Supplement 17 to the 04 series of amendments to UN Regulation No. 44 (Child Restraint Systems)

Submitted by the expert from the European Association of Automotive Suppliers

Figure A

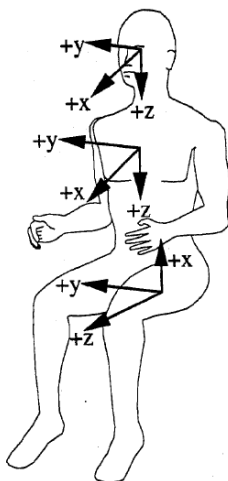
"7.1.4.2.2. The vertical component of the acceleration from the abdomen towards the head, **"-z", when the measurement procedures defined in paragraph 8.5 of this document** are followed, shall not exceed 30 g except during periods whose sum does not exceed 3 ms. **The measurement procedures defined in paragraph 8.5 of this document follow those of ISO 6487 with SAE J211 sign convention, as shown in Figure A.**
